# Staff Report for Administrative Approval Hillside Review – Notice of Conditional Approval

Weber County Planning Division

**Application Request:** Consideration and action on a request to approve a Hillside Review for the Mariani residence located on Lot 5 in the Big Sky No. 1 Subdivision.

**File Number:** HSR 2016-09

**MARIANI RESIDENCE**  
GRADING & DRAINAGE PLAN

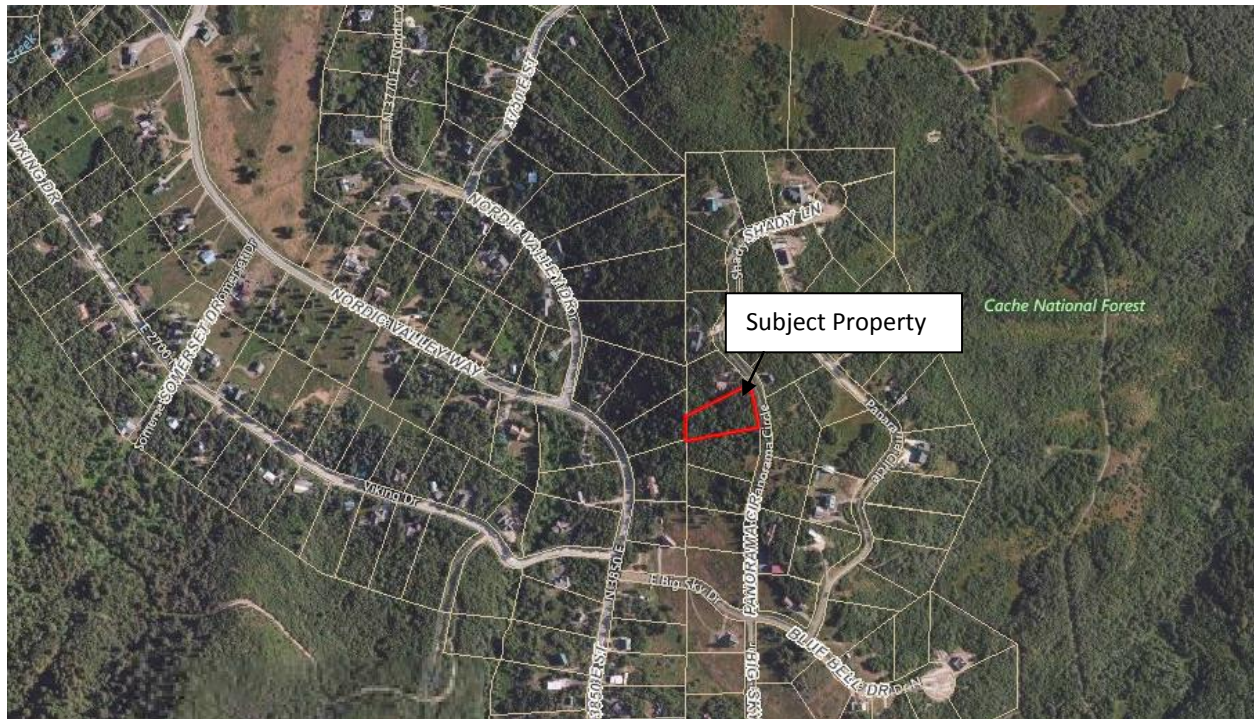
Weber County Engineering Division: The Engineering Division granted approval on August 30, 2016. The approval is subject

to the applicant following all recommendations found in the applicable Geotechnical and Geological Investigation Reports and based on the following conditions:

1. Geologic staff must be on site to observe and test during site preparation and earthwork.
2. GSH must review the final grading plans for the project prior to initiation of any construction.
3. Surface drainage at the crest and toe of slopes, as well as on the uphill side of structures shall be diverted to keep from raising groundwater levels.

No drain field may be installed on sloped in excess of 25%, and excavating to create slopes less than 25% by removal of topsoil may remove all permissible soils and should not be done before submittal and approval of a grading plan to our office.

As part of the hillside review what must be submit to our office is the location of a reasonably sized original and replacement septic drain field utilizing the aforementioned application rate, and the number of bedroom of which the system is being designed. If grading is required to accomplish the required footprint of the original and replacement septic drain field then a grading plan showing initial and post grading will be required.

3. GSH must review the final grading plans for the project prior to initiation of any construction. A letter from GSH approving the final grading plans shall be provided to the Weber County Engineering Division.

6. A subdrain system must be installed upslope of the home and near the head of the mass movement deposit soils below the home to reduce the potential for surface water infiltration
